16. COA-079731-2020

605 North 21st Street

STAFF REPORT

Construct a rear, two-story, accessory dwelling unit.

Figure 1. Subject block, Sanborn Map 1905

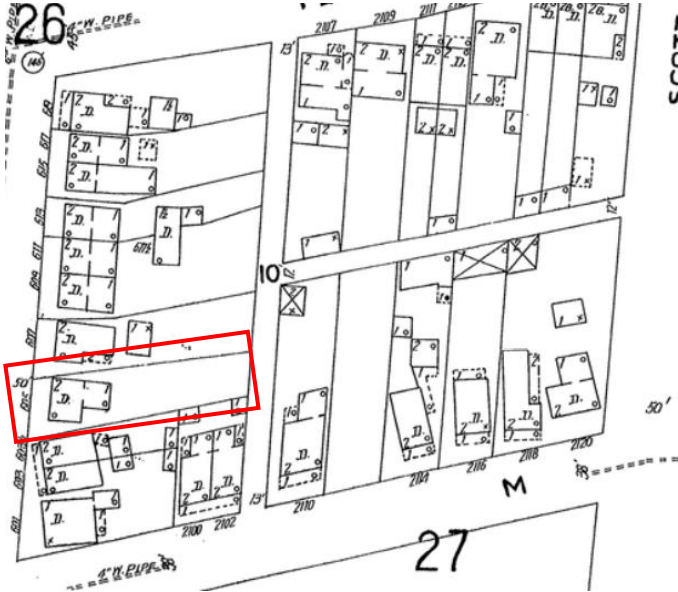
While the mass of the proposed secondary building is smaller than the primary resource, staff is concerned that it appears to be similar in height. Sanborn maps do not indicate the presence of an outbuilding on the site historically, and staff recommends that the height of the building be reduced. Staff also notes that historically there were two-story secondary buildings present on the block, though the majority were one-story.
